Access Compliance Report

Public Rights-of-Way

(Curb Ramps)

| Intersection ID: 48429 | Main Street: ROUSAY_RD | Cross Street: SEAMILL_RD | Location: SE |

| ADA ID: 914866DA3376 | Ramp Type: PerpDiag | Initial Pass/Fail: Fail | Overall Compliance: No |

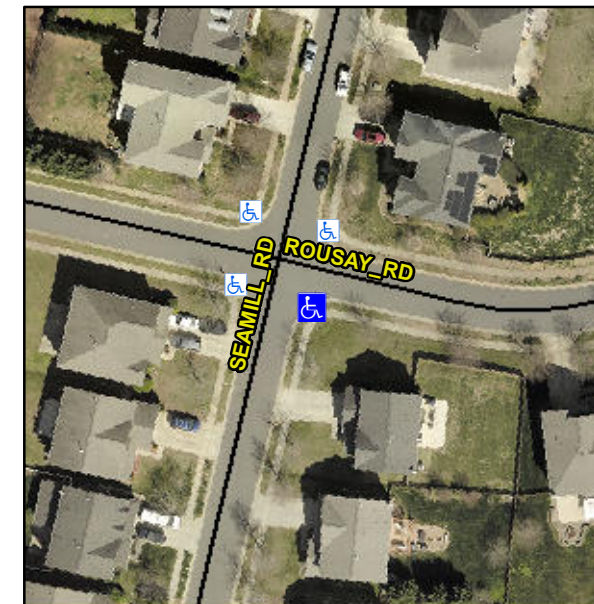
Not Found, R304.5.1, R304.2.2

| Compliance | Description | Data | Compliance | Description | Data |
|------------|-----------------------|-------|------------|-----------------------------|-------|
| N/A | Ramp Length (in) | 47.5 | No | Ramp Slope (%) | 9.0 |
| No | Ramp Width (in) | 47.0 | Yes | Ramp XSlope (%) | 0.1 |

Remove & Replace Curb Ramp With Two New Directional Ramps or Equivalent.
